**REVIEW TYPE:** Preliminary Plan Review

**APPLYING FOR:** Resubdivision of Part of Parcel 2-A, Block 1, Capital View Park

**PROJECT NAME:** Capitol View Park

**CASE #:** 1-03039

### CAPITOL VIEW PARK PROPOSED LOTS 46 & 47, BLOCK 1 PRELIMINARY PLAN

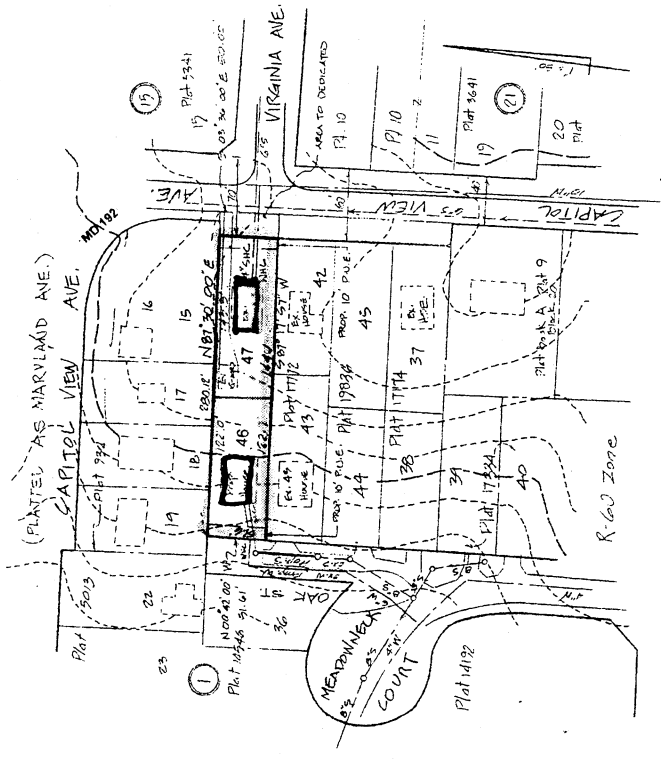
**The HPC recommends denial of this proposed subdivision.** The Commissioners felt that the proposed subdivision plan would negatively affect the historic character of the district by the reduction of the trees and open-space behind the resources fronting Capitol View Avenue.

- Access to this new lot is through a common driveway. It is bound by a maintenance agreement as referred to in Liber 13338 folio 524-534 as well as liber 13576 folio 506-516 (see attached). As the easement agreement(s) clearly show(s), the driveway must remain unobstructed at all times, and no vehicles shall be parked in or on the joint driveway at any time. This renders any major construction project virtually impossible, as it would mean that the driveway would have to be obstructed. Furthermore, as shown in the attached photographs, the driveway is very narrow, with only enough room for one car at a time. Obstruction is thus inevitable if construction occurs, rendering access to our house impossible. Being the last house at the end of the driveway, we are concerned that vehicles will need to use our private garage driveway to turn around. Please be advised that under no circumstance we will allow anyone to use our private garage entrance to maneuver their equipment.

- The Commission must also take into consideration that the lot itself is small by local standards. In fact, we would argue that this is not a lot, but merely a backyard. A house built there would be surrounded on three sides by other houses' backyard. This is not enhancing the quality of the neighborhood in anyway. Furthermore, It is in everyone's benefit that all regulations regarding minimum lot and house size and minimum distances from property lines be fully enforced. We are skeptical that a respectably-sized single-family home can sit comfortably on this lot. The quality and charm of the Capital District Historical area must be preserved. I strongly suggest that members of the commission take the time and come to see for themselves where the lot is situated before making a decision. We are positive they will realize that this is not a lot to build a house.

- 1) Applicant to submit a detailed tree protection and grading plan to MNCPPC technical staff prior to recordation of plat
- 2) Record plat to reflect common ingress/egress and utility easements over all shared driveways

- 6) During the course of construction on Lot 46, there shall be no vehicles, construction or otherwise, parked within the combined right-of-way servicing Lot 38, 43 and 44. Access to Meadowneck Court and Lee Street shall remain open at all times to incoming and outgoing traffic.
